**PLANNED UNIT DEVELOPMENT
& SUBDIVISION STAFF REPORT****Date: June 19, 2014****DEVELOPMENT NAME**

Cobblestone Subdivision, Phase II

Planned Unit Development Approval to allow reduced
sideyard setbacks, and Subdivision approval to create 1 lot.

SITE PLAN

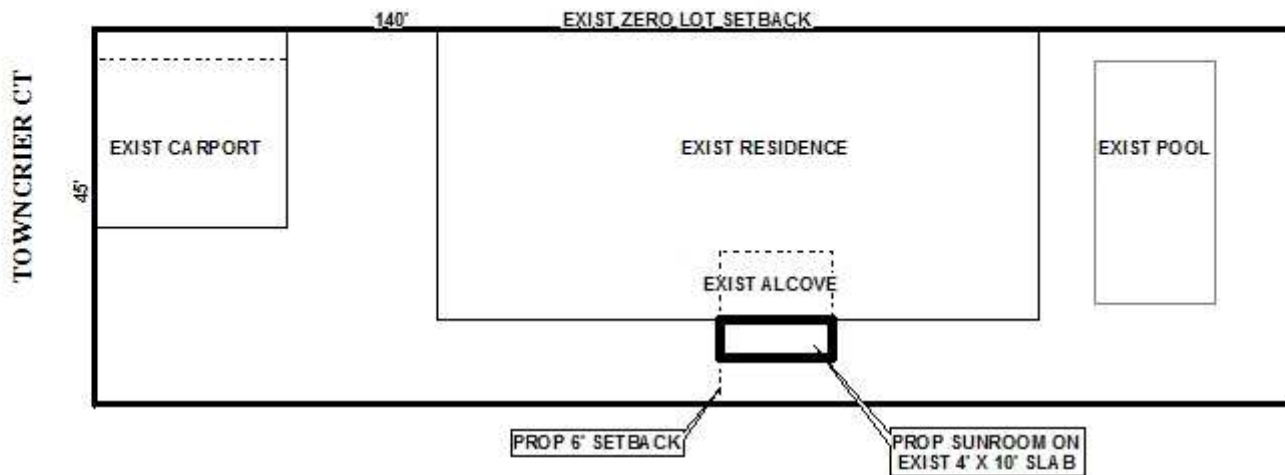
Planned Unit Development: ADD THE FOLLOWING NOTES TO THE PUD SITE PLAN:

The preliminary plat shows the 25-foot minimum building setback line, however, it does not include the lot size. The plat should be revised to also label the size of the lot in square feet.

- 6) Placement of a note on the site plan stating that the 6-foot side yard setback shall only apply to that area adjacent to the sunroom addition, and that the remainder of the side yard shall maintain a 10-foot side yard setback; and

- 7) Provision of a revised PUD site plan prior to the completion of the sun room addition.
